FAQ Title NFPA 805 Monitoring

Plant: Harris Nuclear Plant **Date:** February 1, 2012
Contact: Joelle DeJoseph/ Dave Miskiewicz **Phone:** 919-546-6247
Email: joelle.dejoseph@pgnmail.com

The purpose of this FAQ is to clarify the following for the NFPA 805 monitoring program:

Figure E-1 – NFPA 805 Monitoring Process

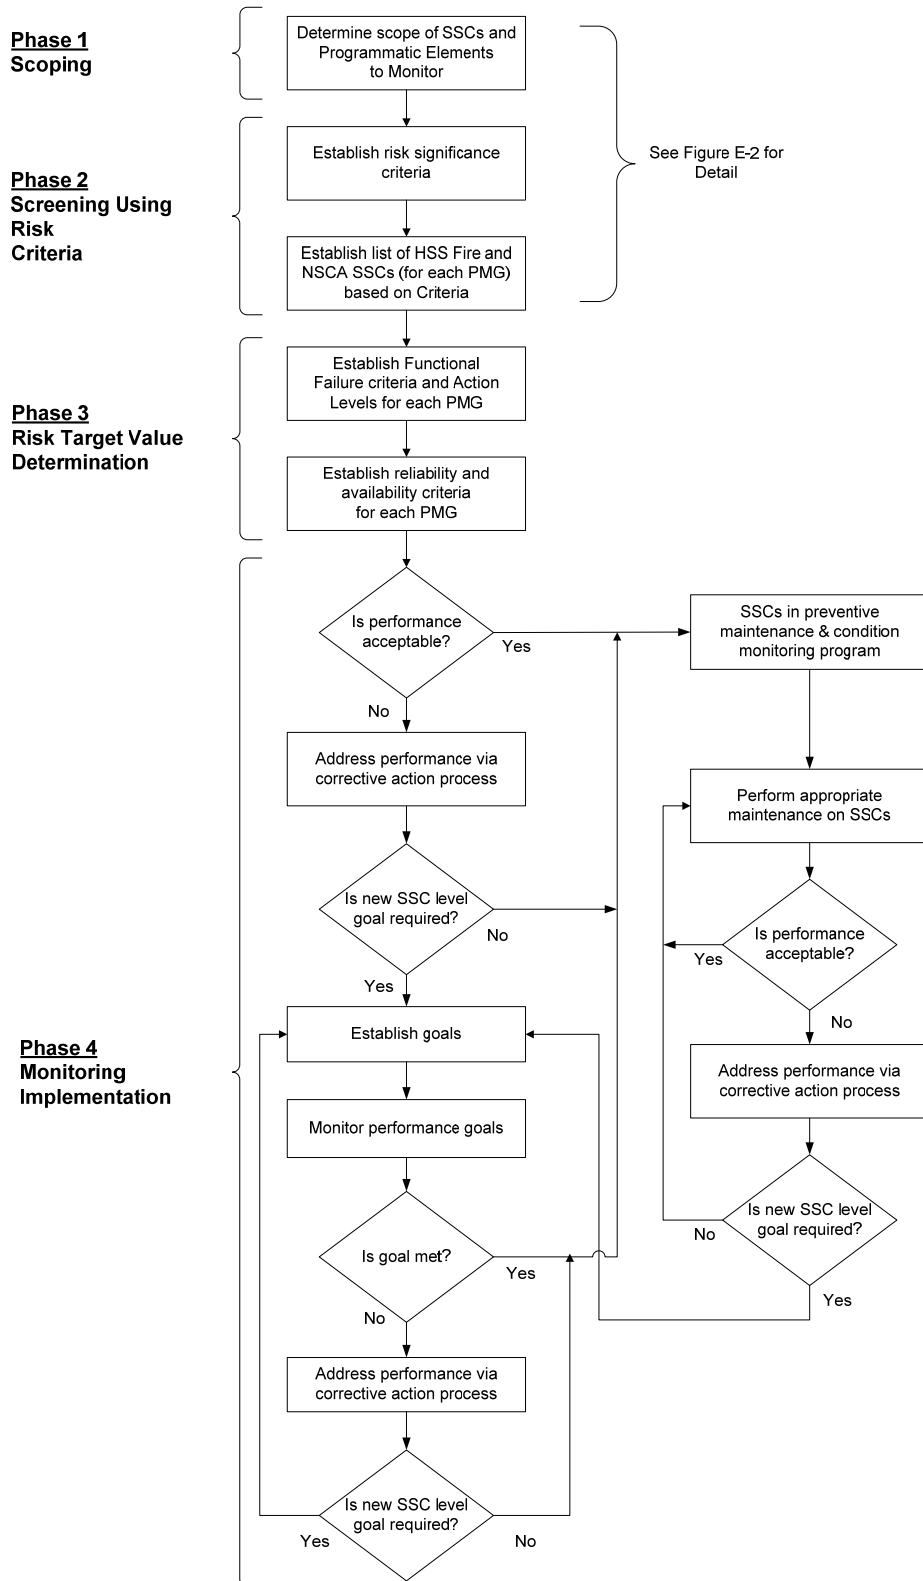
REPLACE ALL OF APPENDIX E WITH THE FOLLOWING:

A suggested methodology is outlined below. Figure E-1 provides an overview of the Monitoring Process, while Figure E-2 provides detail on a process for Phases 1 and 2.
